APPLICATION NO.	FILING DATE	FIRST NAMED INVENTOR	ATTORNEY DOCKET NO.	CONFIRMATION NO.
10/583,938	09/01/2006	Sebastien Bardon	0543-1009	4642

Office Action Summary	Application No. 10/583,938	Applicant(s) BARDON ET AL.	
	Examiner ANTHONY SHUMATE	Art Unit 1797

DETAILED ACTION

Fig. 4

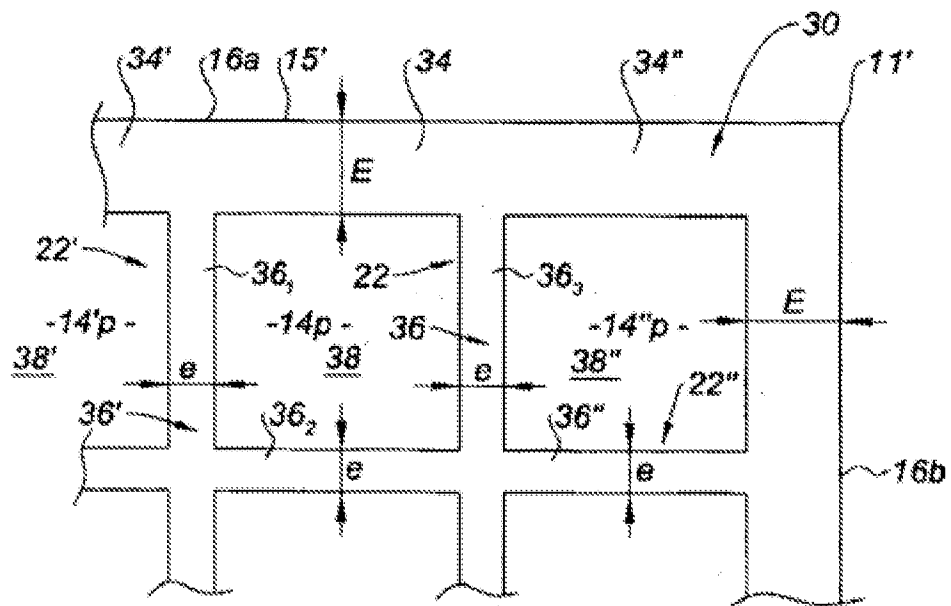
which are confusing. Instant figure 4 has “channels being bounded by side walls,” not “a side wall.” As well, instant figure 4 has, “a side wall of at least one of said channels with a reinforcement compared to remaining side walls,” not “a first portion of the side wall of at least one of said channels, called, ‘reinforced channel’, comprises a reinforcement compared to remaining portions of said side wall.” Therefore, the claim is confusing when compared to the drawings, and this confusion appears to be substantially the result of the use of the phrase, “side wall.”

The Examiner notes the instant figure 4,

FIG. 5

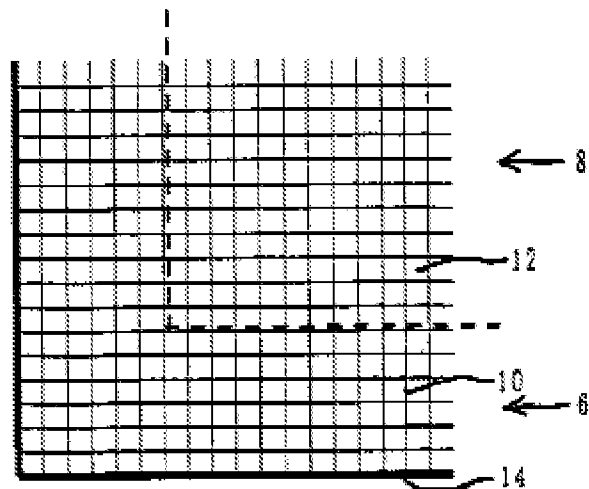
and figure 5 of HASHIMOTO

For instant claim 20, HASHIMOTO teaches at the figures particularly figure 5 and column 5 lines 22-33 wherein channels with the reinforcement (14) (i.e. the reinforced channels of the group) extend to a periphery of the block (2).

For instant claim 21, HASHIMOTO teaches at the figures particularly figure 5 and column 5 lines 22-33 wherein the first portion (14) has an external face defining an exterior of the block (2).

For instant claim 22, HASHIMOTO teaches at the figures particularly figure 5 and column 5 lines 22-33 wherein channels with the reinforcement (14) (i.e. the reinforced channels of the group) are arranged so that the reinforcing partition (14) overlaps a longitudinal edge of the filter block (2).

For instant claim 23, HASHIMOTO teaches at the figures particularly figure 5 and column 5 lines 22-33 wherein channels with the reinforcement (14) (i.e. the group of reinforced channels) comprises all peripheral channels of the block (2) so that the reinforcing partition surrounds the block (2), so that the reinforcing partition (14) is at an external surface of the block (2).
